ND-17-2032  
10 CFR 50.55a

Southern Nuclear Operating Company  
Vogtle Electric Generating Plant Units 3 and 4  
Response to Request for Additional Information Regarding Application of VT-1 Visual  
Examination Methodology for Preservice Inspection of the  
Reactor Vessel Nozzle Inner Radius Sections (VEGP 3&4-PSI-ALT-07S1)

**Response to Request for Additional Information Regarding Application of VT-1 Visual  
Examination Methodology for Preservice Inspection of the  
Reactor Vessel Nozzle Inner Radius Sections (VEGP 3&4-PSI-ALT-07S1)**

**Figure 1. Probability of Correct Rejection Sizing, Acceptable Flaw Size 0.15 (Reference 1)**

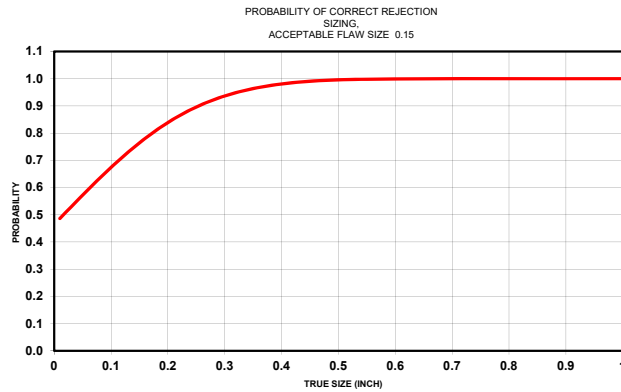
The request notes that you plan to adopt Code Case N-648-1, "Alternative Requirements for Inner Radius Examinations of Class 1 Reactor Vessel Nozzles," for future ISI, however, even though you do not reference Code Case N-648-2, it appears that your technical basis for application of VT-1 for PSI is based on that code case. Code Case N-648-1 applies only to ISI and is conditionally approved for use by the NRC in Regulatory Guide 1.147, "Inservice Inspection Code Case Acceptability, ASME Section XI, Division 1." Code Case N-648-2 applies to both PSI and ISI, and is currently being reviewed by the NRC staff for incorporation into Regulatory Guide 1.147 based on comments provided during ASME Code meetings. Please confirm that you are basing application of VT-1 for PSI on Code Case N-648-2 and discuss how you have addressed potential NRC staff comments regarding use of this code case for new reactors with no previous operating experience.

Figure 1 depicts the expected rejection probability as a function of flaw size, documented in Reference 1. Correct rejection probability considers the detection capability and the sizing capability for flaws. For example, as shown in Figure 1, the probability of detecting and rejecting a flaw 0.25" into the base material is equal to or greater than 90%.

Examinations using modern technology have been performed industry-wide since 1989, and these examinations were compiled in Table 1 of Reference 1. The table shows that over 550 exams had been completed as of the year 2000, with no indications found. In addition to these examinations, some 2500 examinations had been completed by that time, using earlier technologies, with no indications ever being discovered.
